<i>NCSX RFD Part I</i>	Number: 14-017	RFD Description: Thermocouple Hole Changes
Initiator: Mike Griffith and Phil Heitzenroeder		Organization: Major Tool and PPPL
List of Impacted Documents: <i>(Specification, MIT/QA Plan, SOW, drawing, etc.)</i>		
Cost Impact: <i>(If none, so state): NONE</i>		
Schedule Impact: <i>(If none, so state): NONE</i>		
Quality Impact: <i>(If none, so state): NONE</i>		
State Requirement Deviation is Requested For: <i>(Specification, MIT/QA Plan, SOW, drawing, etc.): SE141-114</i>		
<p><b>Full Description of the Deviation Requested:</b> <i>(Use continuation pages, e-mails, letter, sketches, etc. as needed and include amplifying information as appropriate to support deviation request.)</i></p> <p>From: Griffith, Mike [<a href="mailto:mgriffith@majortool.com">mailto:mgriffith@majortool.com</a>]  Sent: Thursday, March 30, 2006 4:15 PM  To: NKHFlowen@aol.com; royjratc-aol-com-offsite  Cc: pdjord@sbcglobal.net; Bowling, Kevin  Subject: Request for change to 2nd thermocouple on the A casting</p> <p>Since we have yet to revise the drawing for thermocouple changes for section TC1-TC1, we would also like permission to change the configuration of the thermocouple

SE141-114 Type A  
Thermocouple TC2-TC2

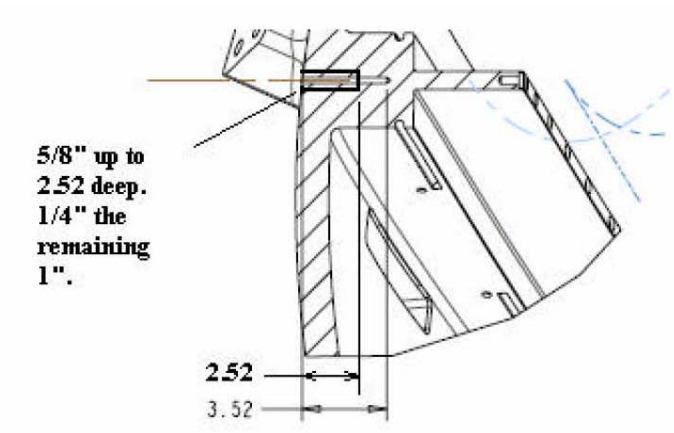
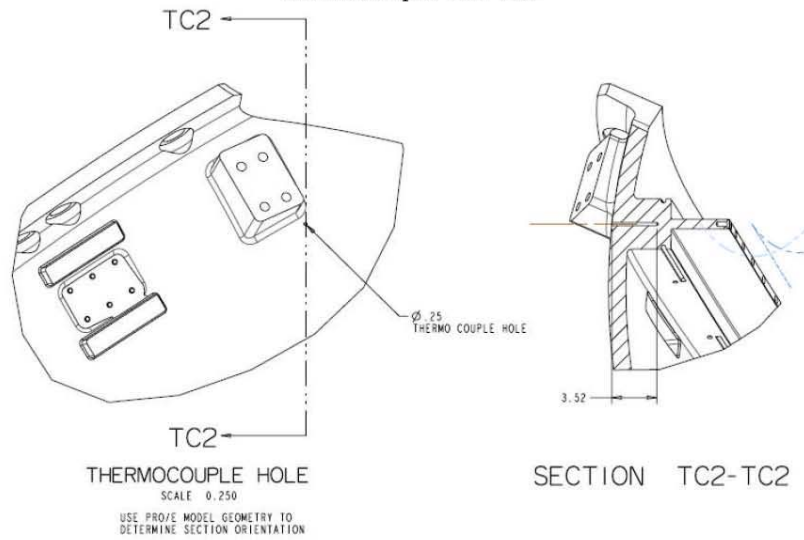
We are requesting a change to the thermocouple in section TC2-TC2 of drawing SE141-114 sheet 9 similar to what has already been approved on the thermocouple at location TC1-TC1.

To facilitate drilling of the thermocouple hole shown in drawing Number SE 141-114, sheet 9, the diameter of the 8.2 inch deep thermocouple hole will be increased to 5/8" for the first 7.2 inches of depth, followed by a diameter of 0.25 inch for the remaining 1 inch depth.
